**From:** Emma Rogerson  
**Sent:** 4/09/2023 3:34:07 PM  
**To:** Council Northernbeaches Mailbox  
**Cc:** Corona Projects Pty Ltd; Robert Steffan; Tracy Steffan  
**Subject:** TRIMMED: DA2022/2207 - 30 Abernethy Street, Seaforth - Submission on behalf of No. 26  
**Attachments:** Submission - 26 Abernethy Street, Seaforth.pdf;

**Submission in regards to the amended DA2022/2207 Development Application  
30 Abernethy Street, Seaforth**

*“Demolition works and construction of a dwelling house including swimming pool as amended.”*

**Figure 6 – Areas of concern along proposed southern elevation (Corona Projects, 2023)**

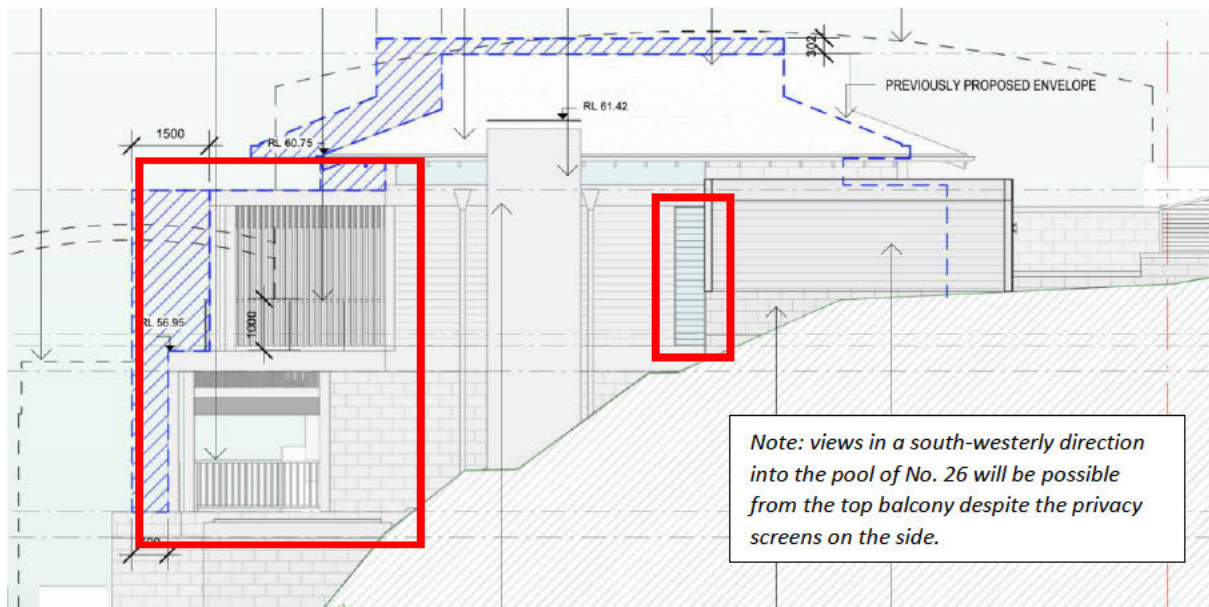
Whilst a privacy screen has been implemented along the southern side of the first floor balcony, this balcony proposed under DA2022/2207 as amended will still allow for direct, unobstructed and close views into the principle private open space of 26 Abernethy Street in a south-westerly direction. Figures 4, 5 and 6 highlight the direction of overlooking and the areas of concern, facilitating views straight into the sensitive rear garden and swimming pool of the dwelling at 26 Abernethy Street, resulting in a substantial and unacceptable visual privacy breach. The ground floor balcony also poses overlooking concerns.

The proposed overlooking is still in conflict with the Part 3.4.2 of the MDCP 2013 which states that development must “*minimise loss of privacy to adjacent and nearby development by appropriate design for privacy (both acoustical and visual) including screening between closely spaced buildings*”.

- d) **Action:** Alongside the building being moved towards Abernethy Street by at least 3m, apply fixed and solid 1.8m privacy screens to any south-facing balcony edges, and frost any side-facing windows. The privacy screen design should minimise additional bulk as far as practical.

Figure 10 – Envelope recommendations

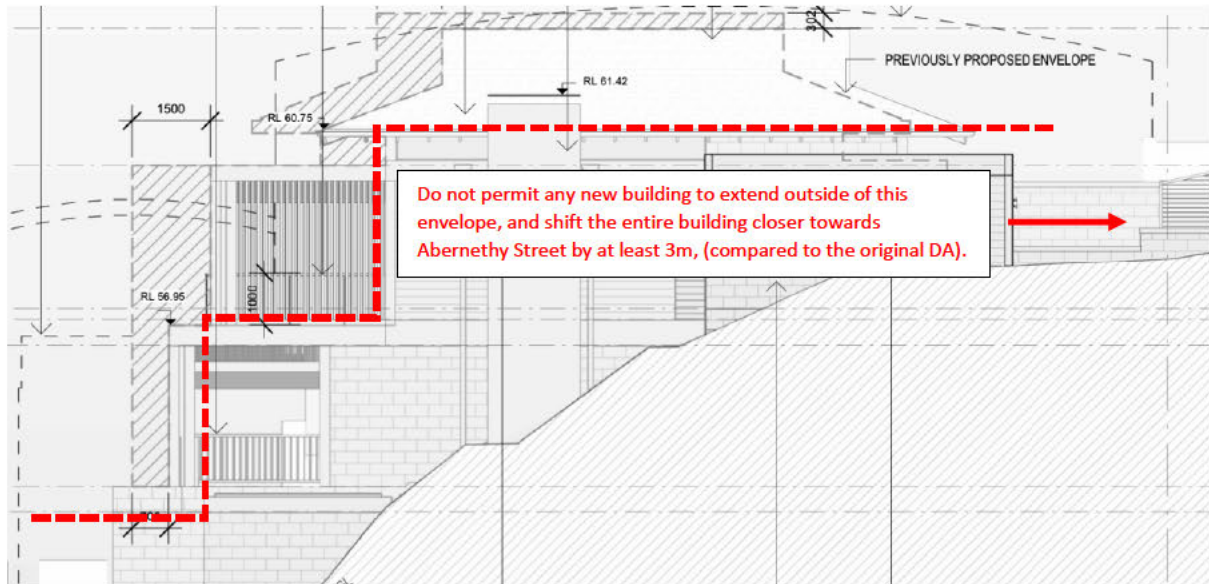
- b) **Action:** Shift the entire building towards Abernethy Street by at least 3 metres (compared to the original DA) and step the building to respect the sloped terrain as shown in figures 10 and 11. This is more consistent with the request of Council's recent RFI letter dated 9 May 2023 to the applicants, and aligns with the approved DA-61/09 for the site.

**Outcome:** This will assist to mitigate overshadowing and visual bulk. It will also achieve a reduction in building height.
- c) **Action:** Alongside the building being moved towards Abernethy Street by at least 3m, apply a flat roof.
